Submission of Further Information (FI)

**Temporary Animal Boarding Establishment with Ancillary Facilities and associated
Filling of Land for a period of 5 years in "Agriculture" Zone,
Lot Nos. 1493 (Part) and 1500 (Part) in D. D. 107 and Adjoining
Government Land, Yuen Long, New Territories
(Application No. A/YL-KTN/1177)**

Further Information for Planning Application No. A/YL-KTN/1177**Response-to-Comments****Comments from Drainage Services Department**

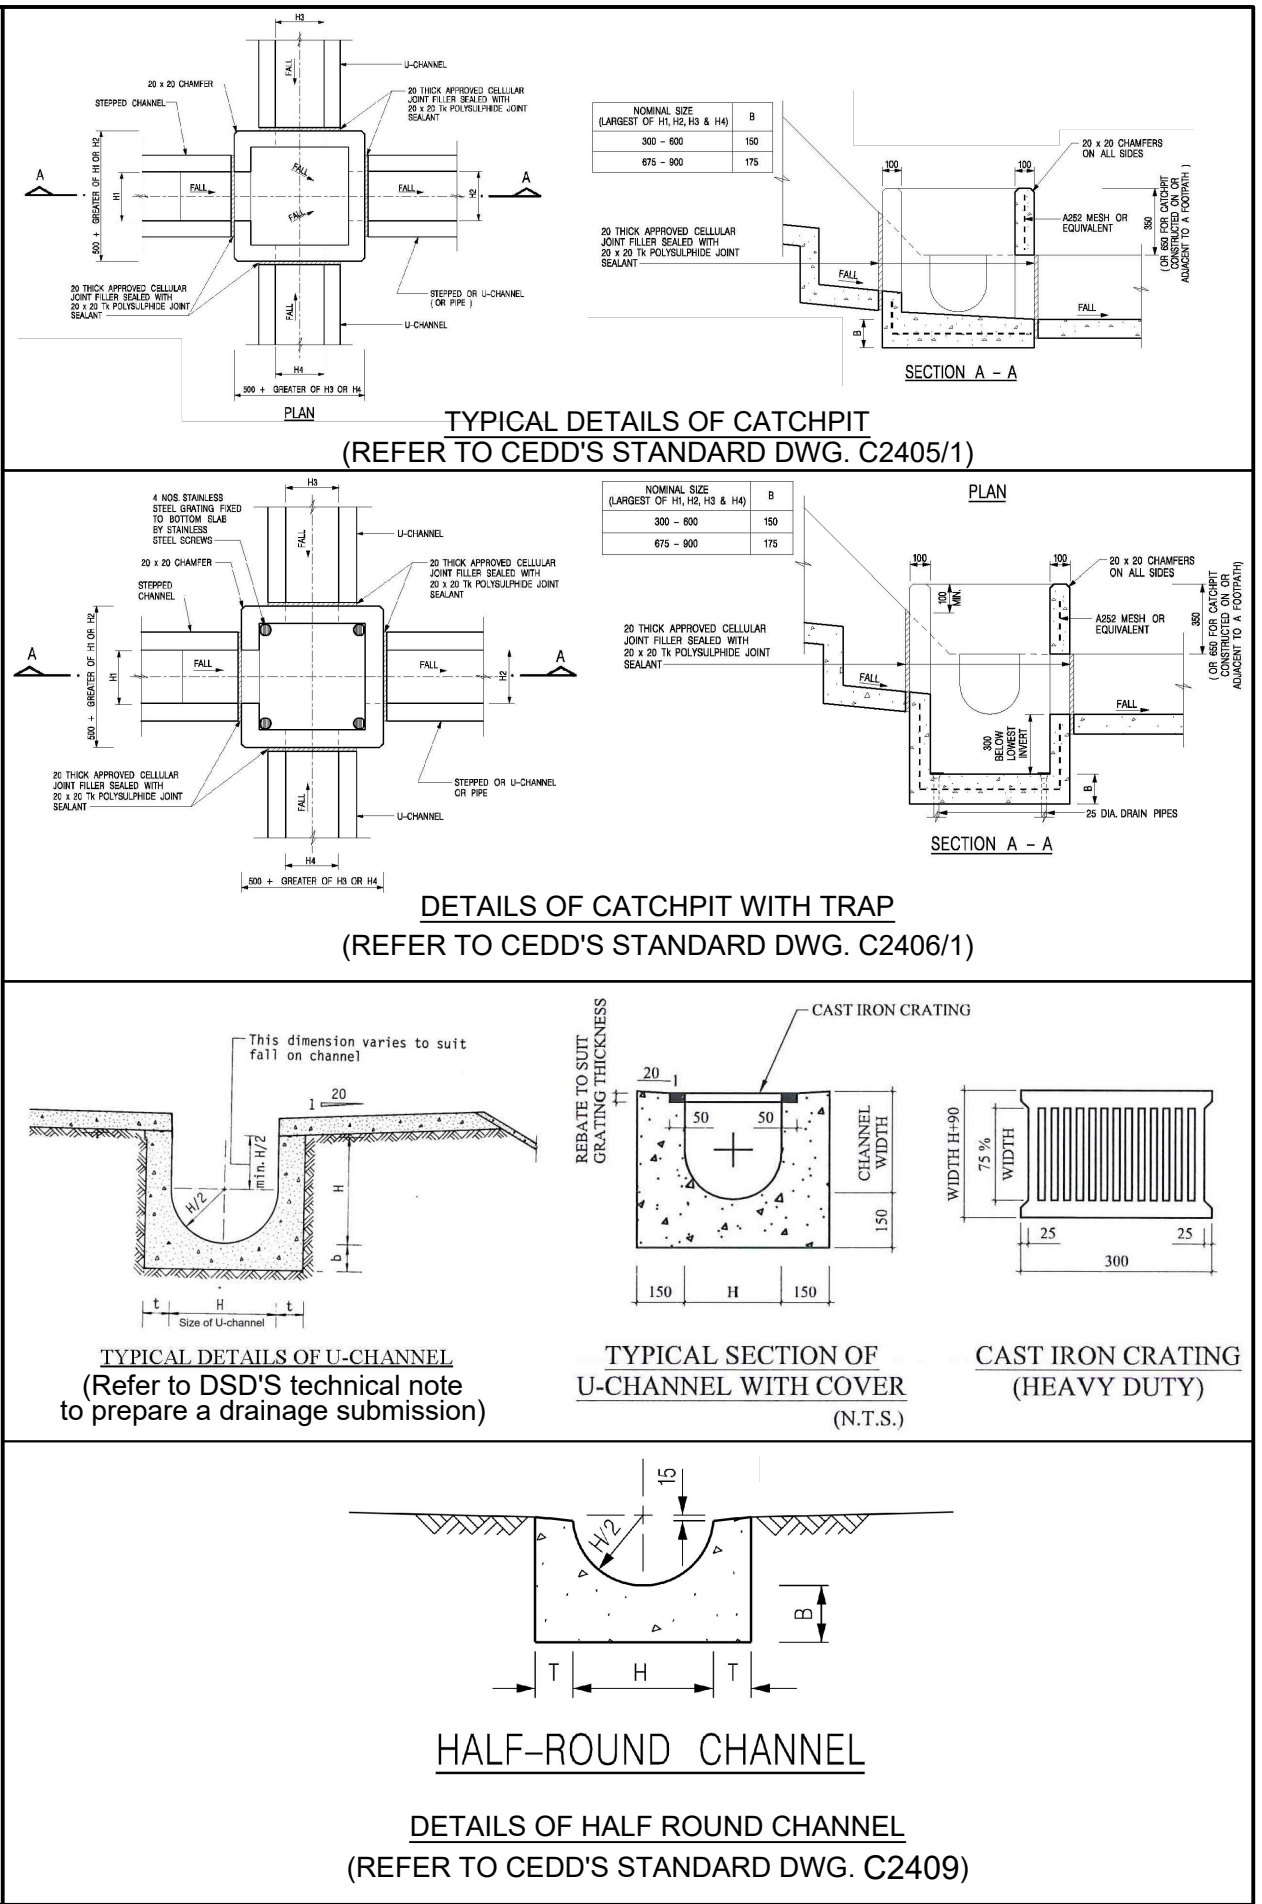
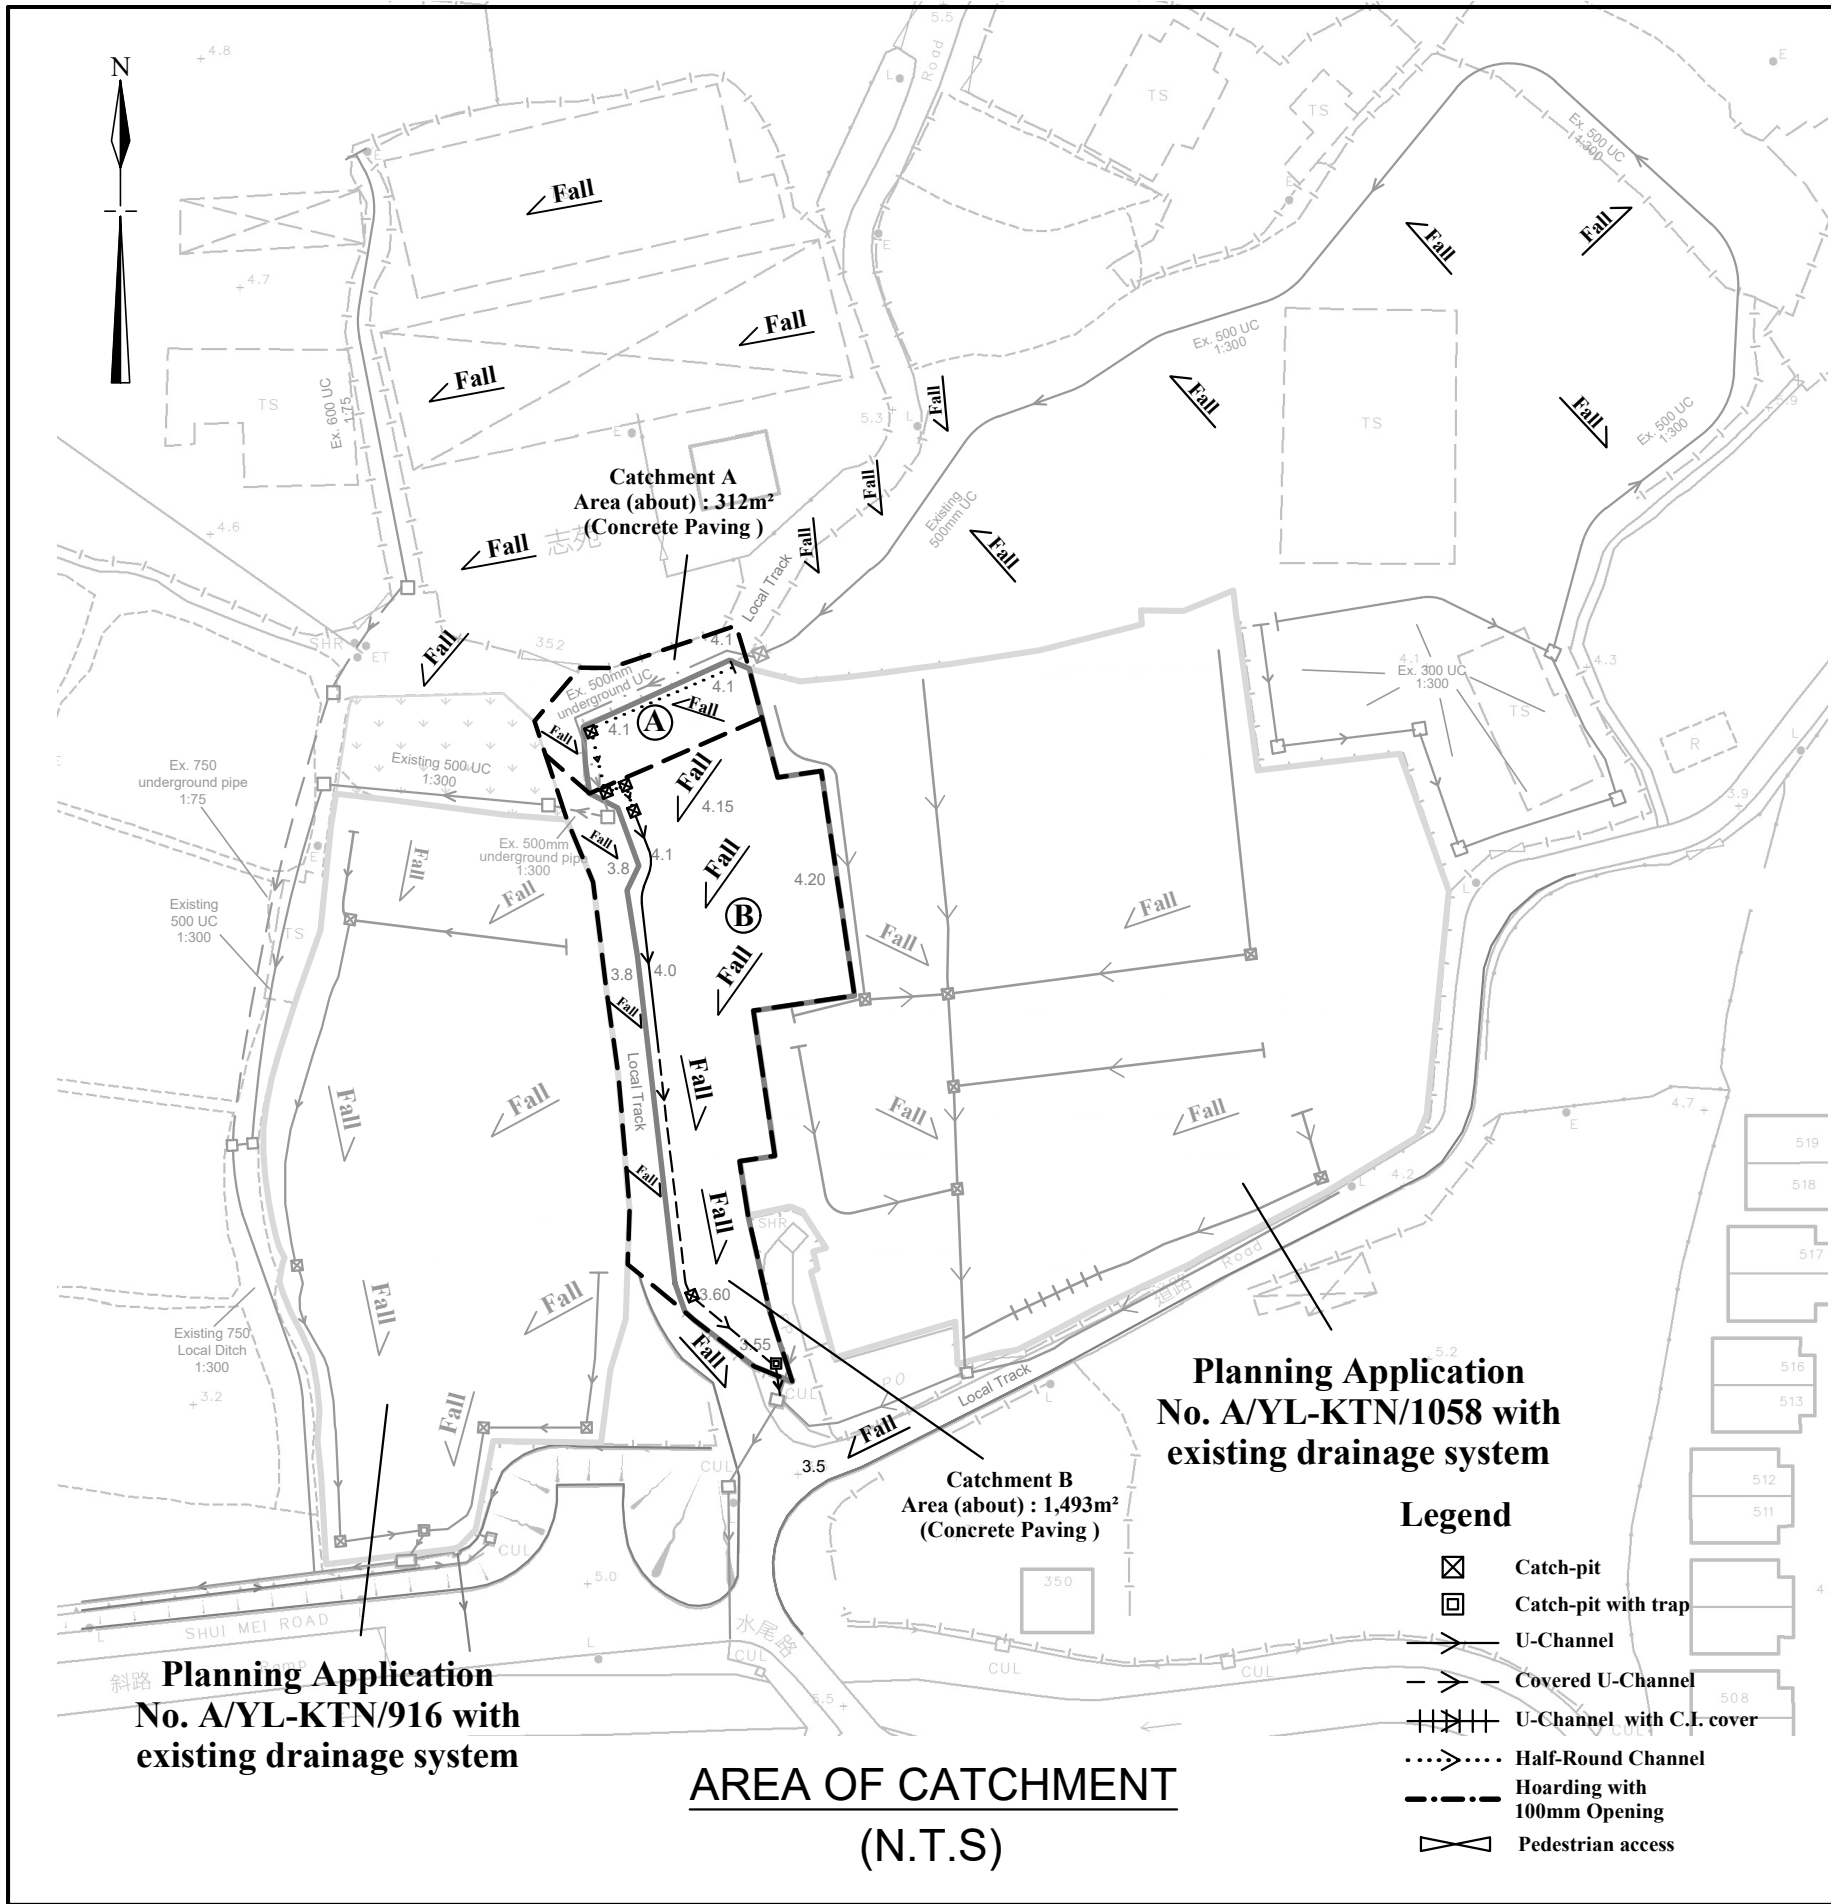
I.	Comments	Responses
1.	Section B - Please review the adjacent site ground levels. According to our record, the adjacent road level is higher than the application site, external catchment area should be considered. Please update the section and calculations if necessary.	External catchment area of the adjacent road is included. Please refer to updated Drainage Proposal (Plan 6.1b and Plan 6.2c) and Hydraulic Calculations for details.

3.	Plan 6.1b: The applicant should review alignment of the proposed drainage facilities connecting catchpits CP2 and CP4.	The alignment is updated. Please refer to Plan 6.1b.

4.	Plan 6.1b & 6.2b: The applicant should clarify the proposed and existing ground levels of the application site and ground levels of adjacent areas. Cross sections showing the proposed drainage facilities and existing and proposed ground levels of the captioned site with respect to the adjacent areas should be given.	Noted. Please refer to sections at Plan 6.1b for the proposed and existing ground levels of the application site.
